Site: Rohan Subdivision

Re: Drainage Ordinance (14-5-2-1) Violations for Erosion and Sediment Control

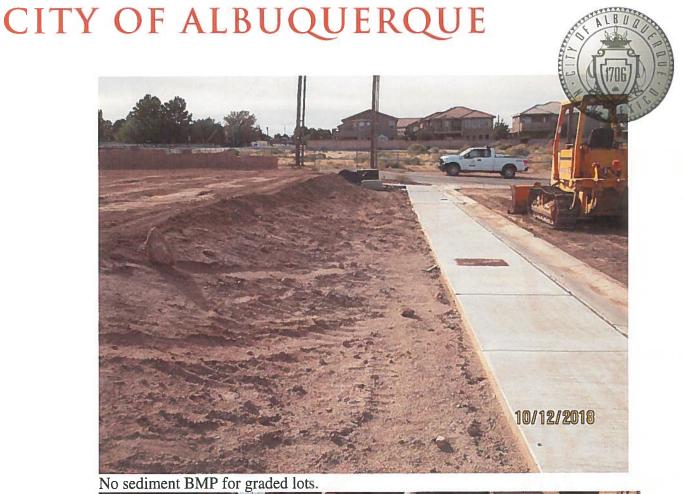
Sediment in gutter and on top of curb.

No inlet protection.

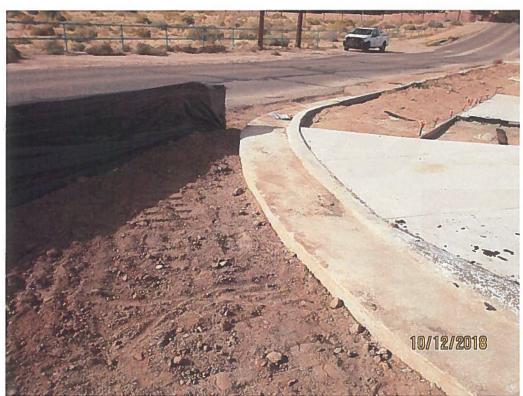
Construction waste and litter pile near channel.

Concrete wash-out.
